SERVICE LETTER #38

SUBJECT: Elevator Control Stop Bushings

APPLICABILITY: All Series 5 Aircraft with S/N's prior to V9410XXXX, S9410XXXX

Figure 1
Control Column Elevator Stop Bushing

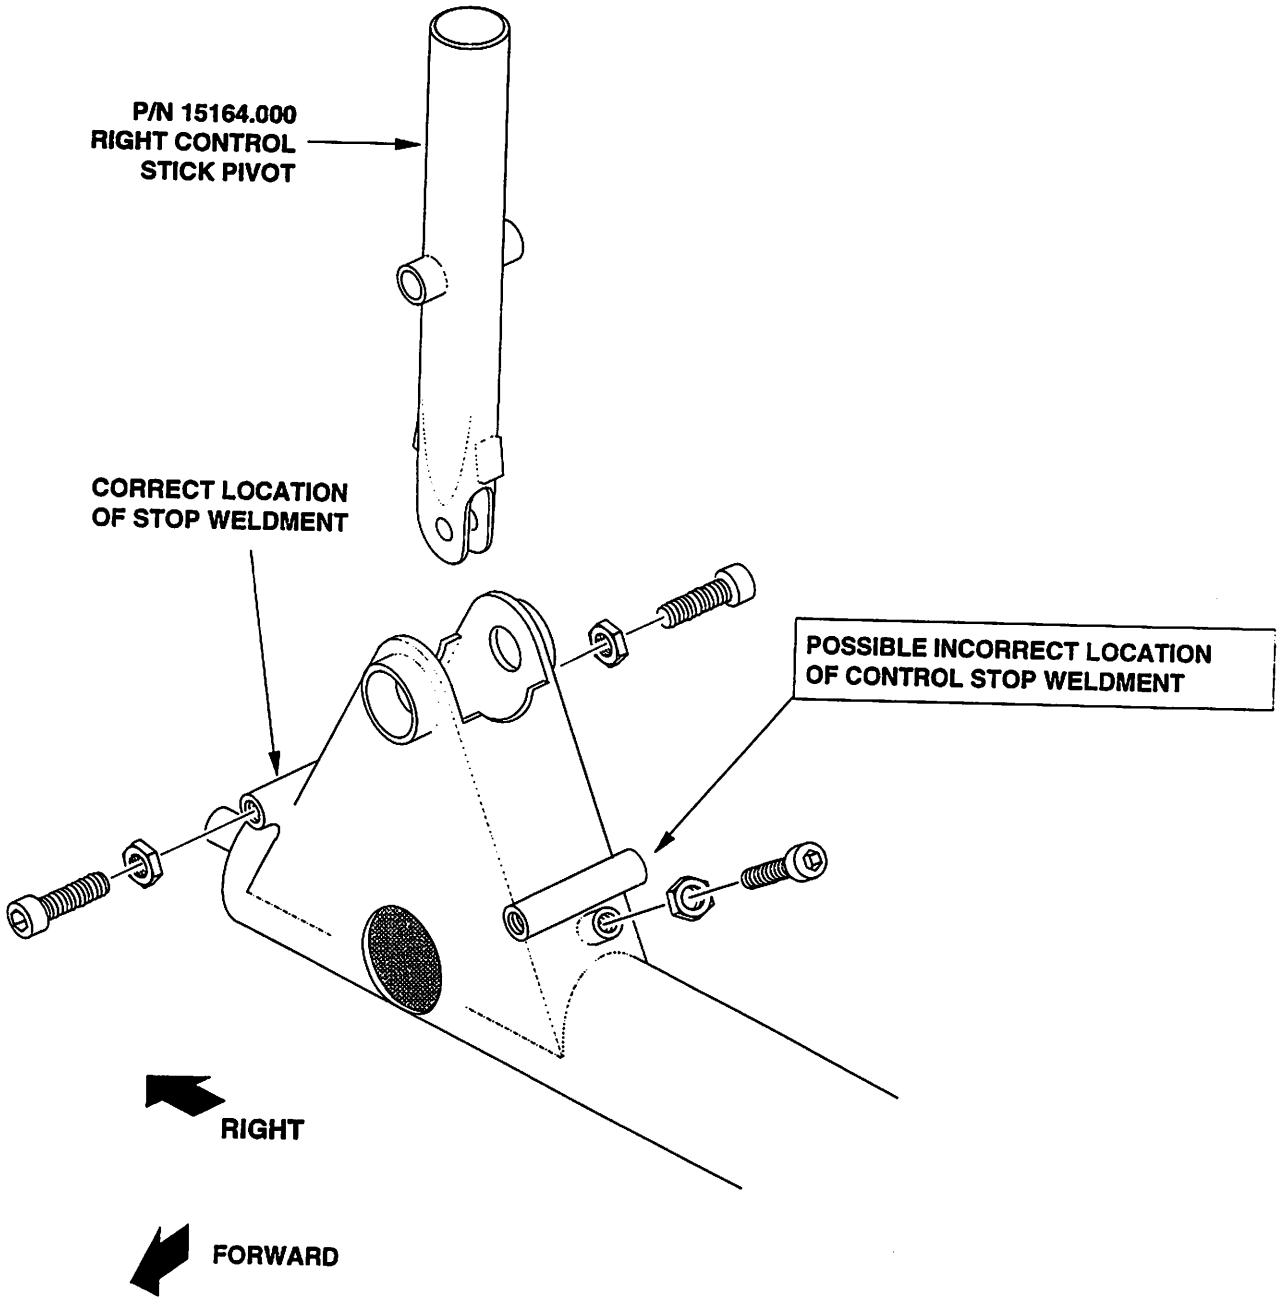
Some Series 5 control column weldments may have been shipped with the elevator control stop bushing welded to the wrong (inboard) side of the column. Examine your parts to determine if your control column was properly configured.

The accompanying drawing illustrates the correct and incorrect locations of the bushing in question.

If your parts are incorrect, return the parts to us and we will correct them for you. Call Customer Service for a Return Materials Authorization number (RMA) so that we may properly track the returned parts.
